## Access Compliance Report Public Rights-of-Way (Curb Ramps)

Intersection ID: 26087Main Street: CARMEL\_CROSSING\_RDCross Street: JOHNSTON\_RDLocation:NWADA ID: EF1DA35B1802Ramp Type: BlendTrans2Initial Pass/Fail: FailOverall Compliance: NoSeverity Score:10

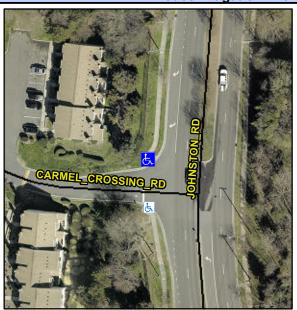
Not Found, R304.5.1, R304.5.3

Compliance Description		Data	Compliance Description		Data
N/A	Ramp Length (in)	123.0	Yes	BlendTrans Slope (%)	4.0
No	Ramp Width (in)	46.5	No	BlendTrans XSlope (%)	3.0
N/A	Flare Type LT	N/A	N/A	Flare Type RT	N/A
N/A	Flare Slope LT (%)	N/A	N/A	Flare Slope RT (%)	N/A
N/A	Flare Traversable LT?	N/A	N/A	Flare Traversable RT?	N/A
N/A	Landing Length (in)	N/A	N/A	DWS Provided?	N/A
N/A	Landing Width (in)	N/A	N/A	DWS Contrast?	N/A
N/A	Landing Slope (%)	N/A	N/A	DWS Length (in)	N/A
N/A	Landing X Slope (%)	N/A	N/A	DWS Full Width?	N/A
N/A	Landing Curb? (Y/N)	N/A	N/A	DWS Offset (in)	N/A
N/A	Shared Landing?	N/A			
N/A	Gutter Ponding?	N/A	N/A	Gutter Slope (%)	N/A
N/A	Gutter Lip Ht (in)	N/A	N/A	Gutter X Slope (%)	N/A
N/A	Painted X Walk1?	No	N/A	Painted X Walk2?	No
	X Walk 1 Direction	To S		X Walk 2 Direction	To E
	X Walk 1 Width (in)	N/A		X Walk 2 Width (in)	N/A
	X Walk 1 Slope (%)	7.6		X Walk 2 Slope (%)	8.2
	X Walk 1 X Slope (%)	0.8		X Walk 2 X Slope (%)	2.1

N/A	Ramp inside XWalk1?	N/A	N/A	Ramp inside XWalk2?	N/A
	Road Slope (%)	0.2		Clear Space?	N/A
	Road X Slope (%)	1.4	N/A	Clear Space to XWalk (in)	N/A
N/A	Any Obstructions?	N/A	N/A	Storm Grate/Utility Hazard?	N/A
	Obstruction Type			Storm Grate/Utility Type	
		N/A			N/A
			Yes	Surface Condition? (G/P)	Good
			No	Curb Slope (%)	11.4

Remove & Replace Curb Ramp With Two New Directional Ramps or Equivalent.
